TOWN OF CORTLANDT PLANNING BOARD

**MEETING AGENDA..... PLANNING BOARD
TOWN OF CORTLANDT
6:30 TUESDAY EVENING*
FEBRUARY 3, 2026**

TO: Planning Board Members

**RECYCLING DETENTION POND
EXISTING CONDITIONS
STR-R2**

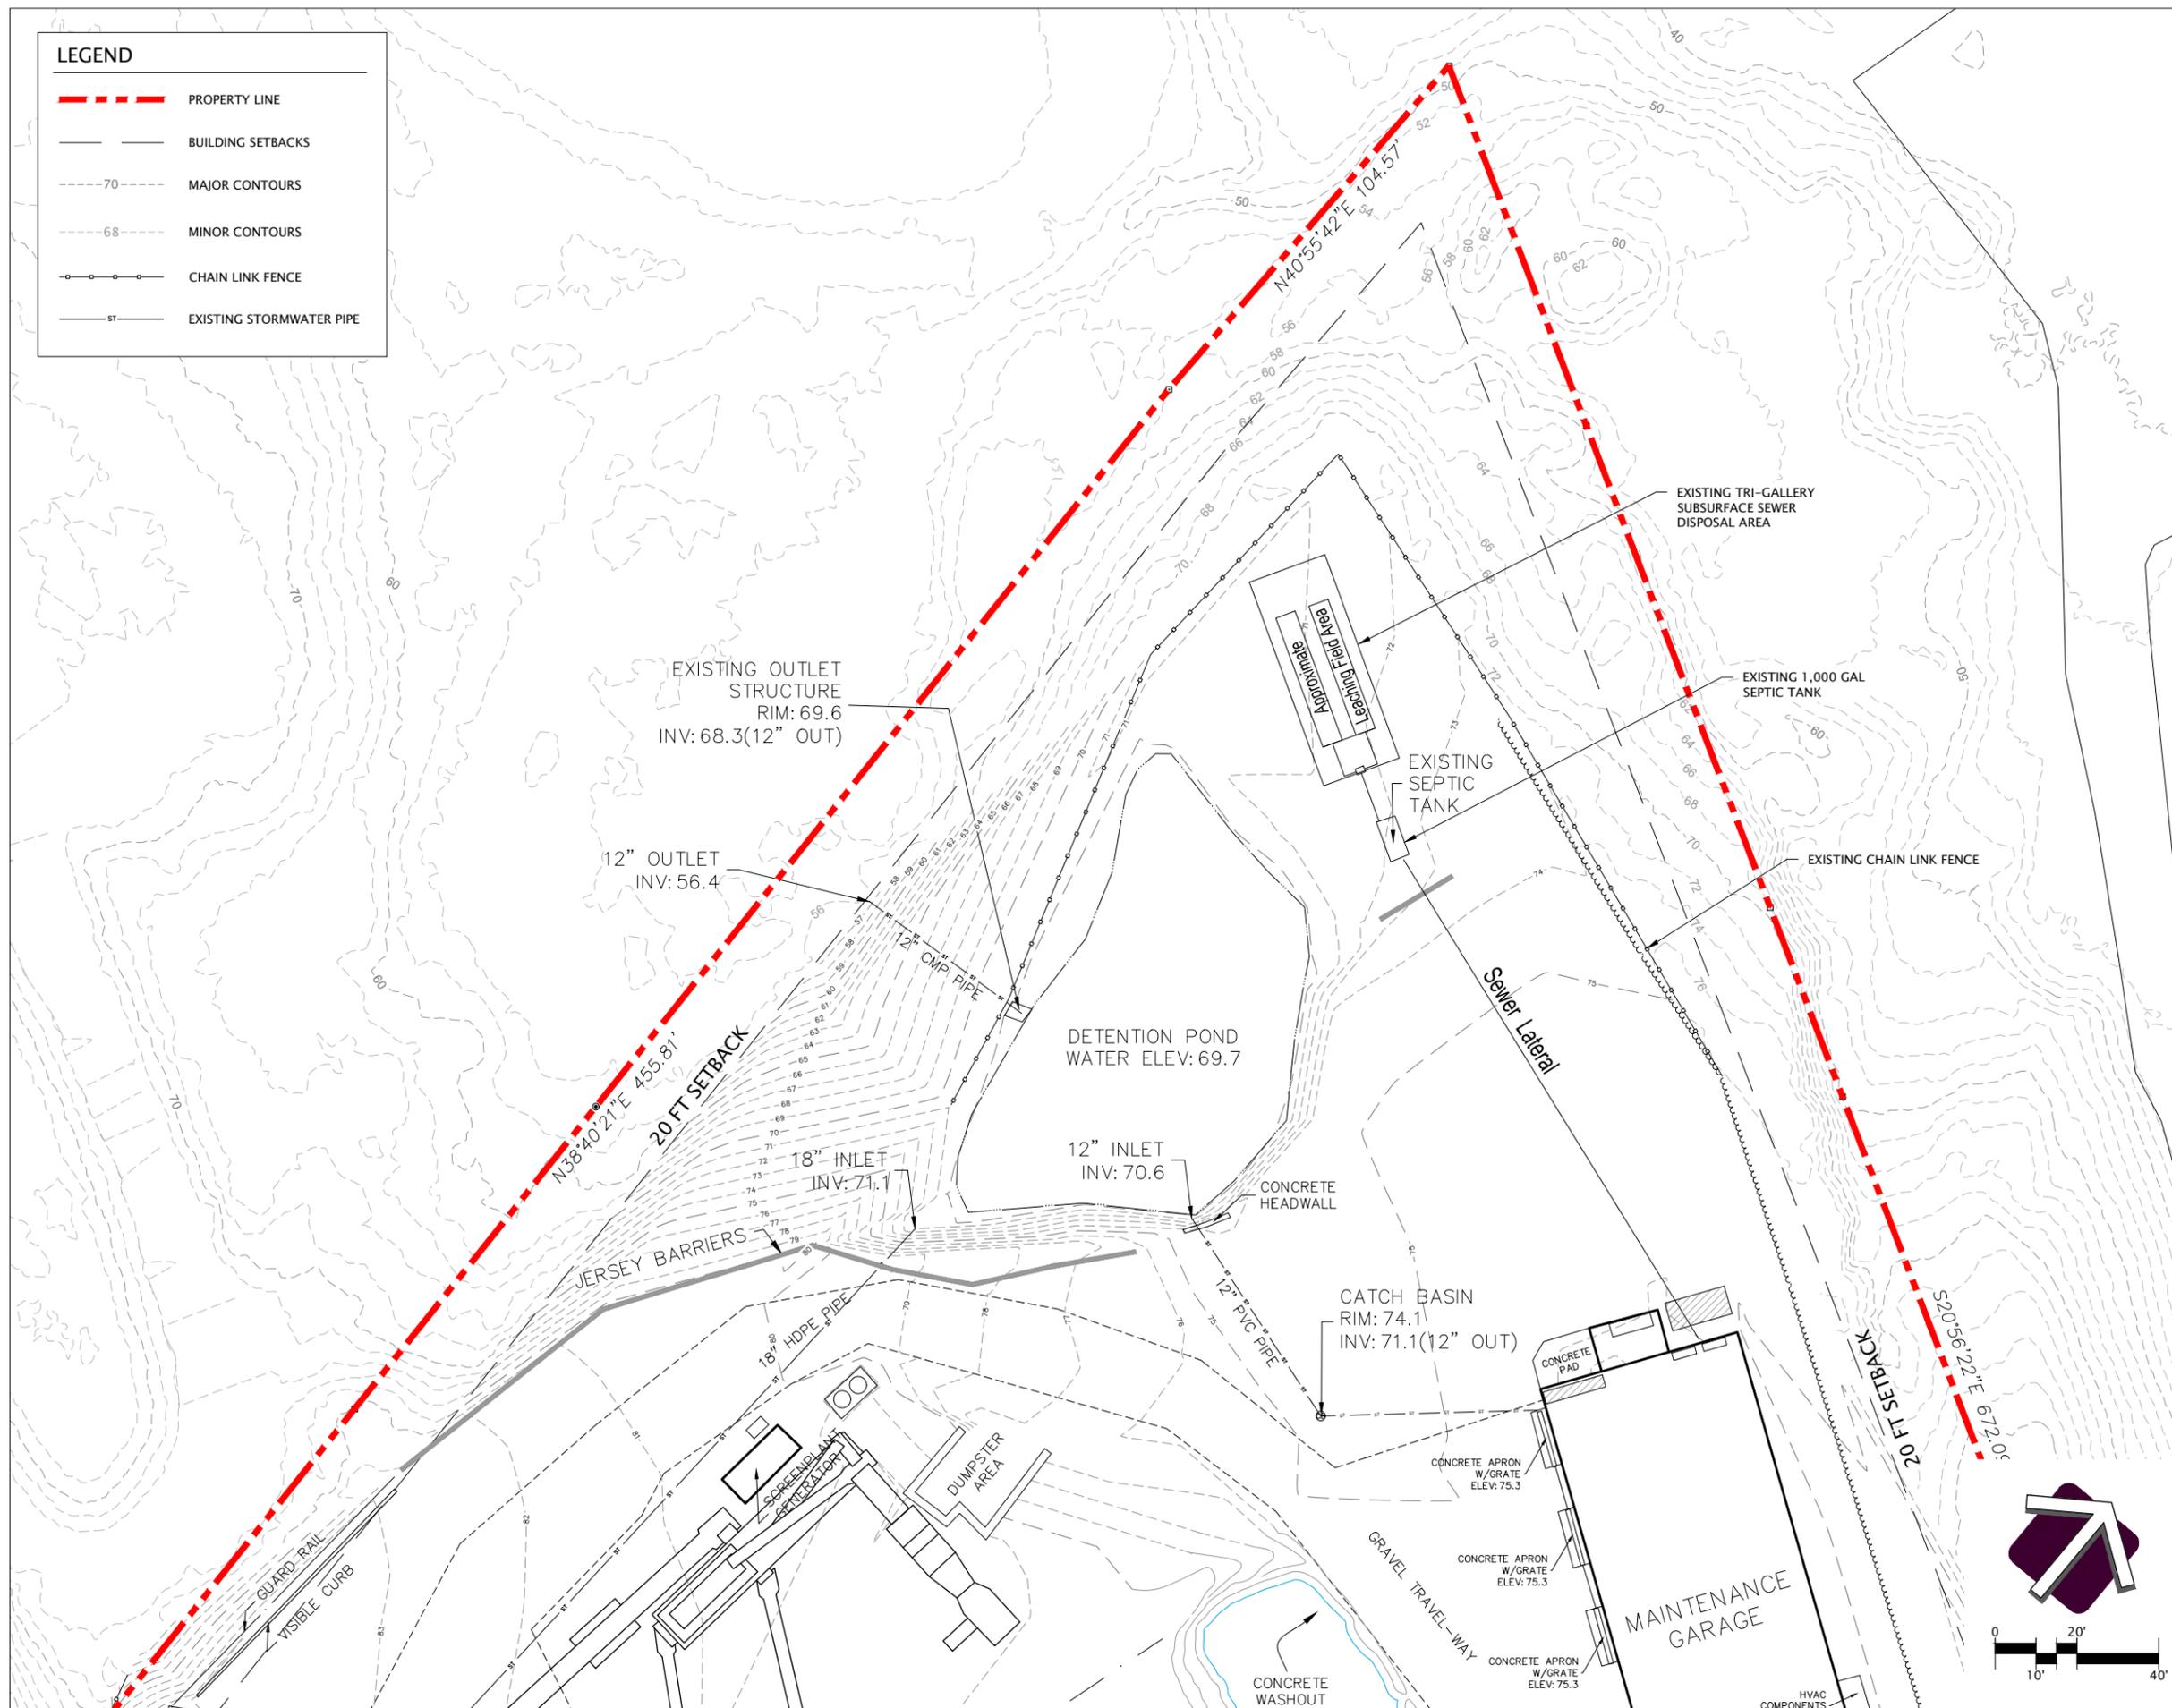
83. *Site Survey – The survey should be updated to match the existing condition features, utilities, and topography on the site plans shown on Sheet CLA-01-CLA-09 and STR-R2.*
